# Santa Barbara Audubon Society

June 14, 2019

RE: Strauss Wind Energy Project – Comments on Draft Supplemental Environmental Impact Report

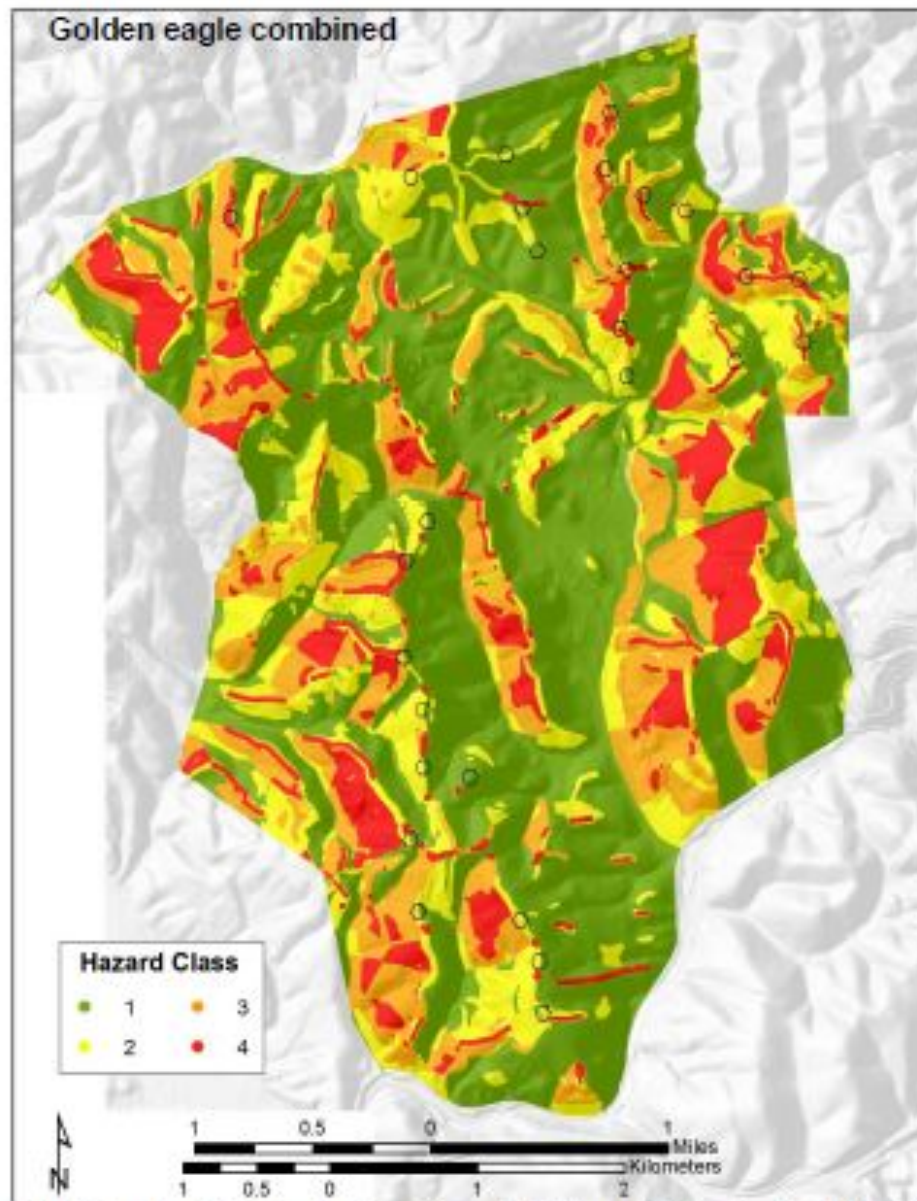
The figure shows that detailed data can be taken on the flight behavior of vulnerable species, such as the Golden Eagle. This data can be used to place WTGs in locations that will reduce avian mortality.
